# Access Compliance Report

## Public Rights-of-Way

### (Curb Ramps)

Intersection ID: 46144	Main Street: EASTFIELD_VILLAGE_LN	Cross Street: ROCKY_FORD_CLUB_RD	Location: N
ADA ID: 28456A96B2A3	Ramp Type: PerpDiag	Initial Pass/Fail: Fail	Overall Compliance: No
Codes/Mitigation Info/Possible Solution		Field Measurements/Component Compliance

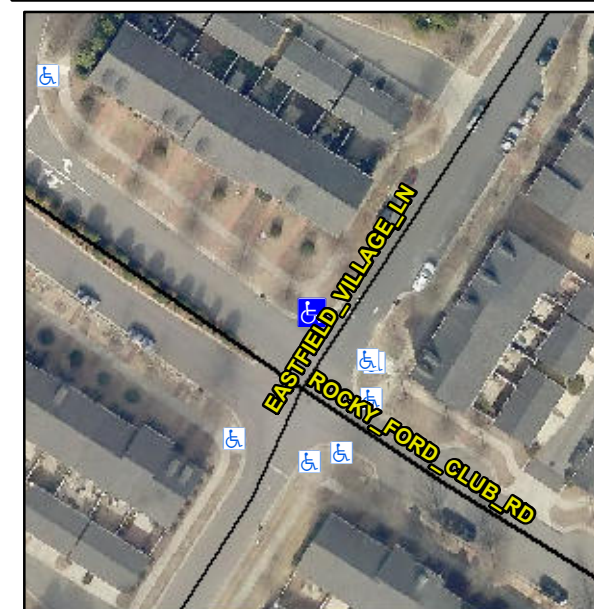
**R304.2.2, R304.5.3**

Compliance	Description	Data	Compliance	Description	Data
N/A	Ramp Length (in)	166.0	No	Ramp Slope (%)	9.6
Yes	Ramp Width (in)	48.0	No	Ramp XSlope (%)	3.9
N/A	Flare Type LT	N/A	N/A	Flare Type RT	N/A
N/A	Flare Slope LT (%)	N/A	N/A	Flare Slope RT (%)	N/A
N/A	Flare Traversable LT?	N/A	N/A	Flare Traversable RT?	N/A
N/A	Landing Length (in)	N/A	N/A	DWS Provided?	N/A
N/A	Landing Width (in)	N/A	N/A	DWS Contrast?	N/A
N/A	Landing Slope (%)	N/A	N/A	DWS Length (in)	N/A
N/A	Landing X Slope (%)	N/A	N/A	DWS Full Width?	N/A
N/A	Landing Curb? (Y/N)	N/A	N/A	DWS Offset (in)	N/A
N/A	Shared Landing?	N/A			
N/A	Gutter Ponding?	N/A	N/A	Gutter Slope (%)	N/A
N/A	Gutter Lip Ht (in)	N/A	N/A	Gutter X Slope (%)	N/A
N/A	Painted X Walk1?	No	N/A	Painted X Walk2?	No
	X Walk 1 Direction	To SW		X Walk 2 Direction	To SE
N/A	X Walk 1 Width (in)	N/A	N/A	X Walk 2 Width (in)	N/A
	X Walk 1 Slope (%)	1.4		X Walk 2 Slope (%)	3.7
	X Walk 1 X Slope (%)	2.8		X Walk 2 X Slope (%)	1.3

**Remove & Replace Curb Ramp With Two New Directional Ramps or Equivalent.**
